**New Reactors Division – Generic Design Assessment**  
**Step 4 Assessment of Chemistry for the UK HPR1000 Reactor**

Assessment Report ONR-NR-AR-21-002  
Revision 0  
January 2022

Figure 4: Simplified Diagram of the RCV [CVCS] (Ref. 33)

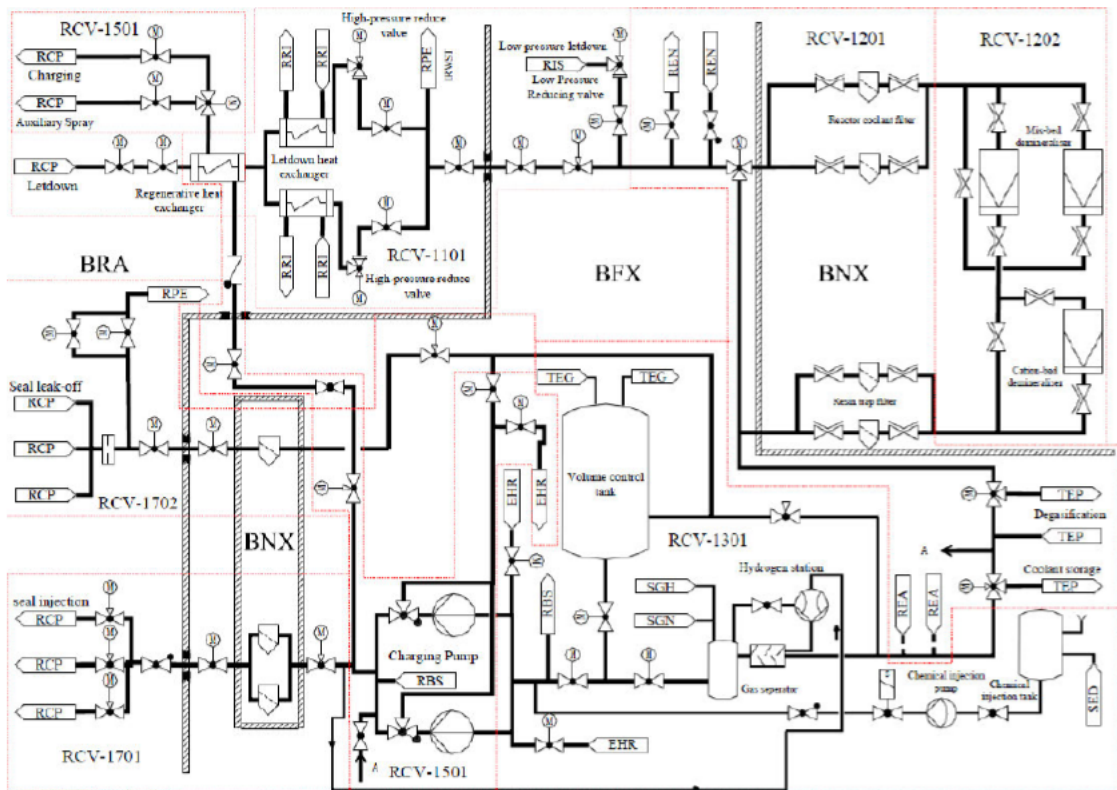
65. The RCV [CVCS] demineralisers play an important role in the control of primary circuit chemistry and represent a crucial element in the generic UK HPR1000 design to fulfil the outlined chemistry functions. One significant aspect of the demineraliser which needs to be considered is the system capacity; ensuring the generic design has taken account of the species present, the operational demands and the duration over which it must operate. The two mixed-bed demineralisers, saturated with lithium and borate ions, are primarily to remove ionic impurities from the primary coolant. The single cationic bed (hydrogen form) controls lithium concentrations within the primary coolant and also removes cationic impurities such as caesium resulting from fuel clad defects.

reported. The RP reported that the quoted capacity is based on CPR1000 Operating Experience (OPEX) where the average resin replacement cycle is typically █ years (mixed bed) and █ years (cation bed). Additionally, there are two mixed bed demineralisers, one in operation and one in stand-by. While a level of redundancy for an 18-month cycle has been outlined for the UK HPR1000, with the ability to instate a second demineraliser should the need arise, no supporting operational data was provided by the RP in response to RQ-UKHPR1000-1292 (Ref. 3).

67. My expectations for the safety case during GDA are that where relevant, plant data from similar plants should be available to support the claims and arguments that the RP makes; during Step 4 of GDA, very little OPEX was included in the generic safety case. I therefore consider this to be an Assessment Finding.

70. My TSC considers that for PWRs, a typical resin replacement frequency is likely to mean a change of resins every operating cycle and noted that the suggested resin replacement frequency of between █ and █ years may not represent a position in which risks are reduced SFAIRP in terms of source term, noting the accumulated activity that such a replacement frequency could result in its report (Ref. 34). Whilst it is important that the function of the RCV [CVCS] should be adequately justified in all aspects, the design of the RCV [CVCS] will be confirmed by the licensee, and an adequate justification of its functions should be conducted as part of normal business.

72. A further important aspect of the operation of the demineraliser is in response to a failed fuel event. In response to such an event; two charging pumps are placed into service, doubling the purification rate. If one of the mixed-bed demineralisers becomes exhausted, then the second is placed into service. The purified letdown flow can be discharged to the degasification unit of the TEP [CSTS] for removing fission gases. Because the lithium-form cation resin has little affinity for the fission product of caesium, the cation bed demineraliser with a hydrogen-form cation resin may be put into operation for removing caesium when needed. This action will also remove lithium, so lithium hydroxide additions by the RCV [CVCS] chemical addition unit may be needed to compensate removed lithium.

AF-UKHPR1000-0011 – The licensee shall, as part of developing the operational chemistry safety case, ensure robust operational plant data is included to support safety case claims and arguments. A methodology should be implemented to identify, select and use relevant data to underpin the safety case. The data should be used to demonstrate, amongst other matters, that the following are appropriate and achievable:

73. My TSC considered that the inclusion of two mixed beds and the cation bed provides sufficient redundancy against the additional loading as a result of failed fuel (Ref. 34). The TEP [CSTS] mixed resin bed (H<sup>+</sup> form) will also provide a degree of redundancy and additional clean-up although this has not been reported against failed fuel. I am therefore content that the arrangements for the purification systems are reasonable.
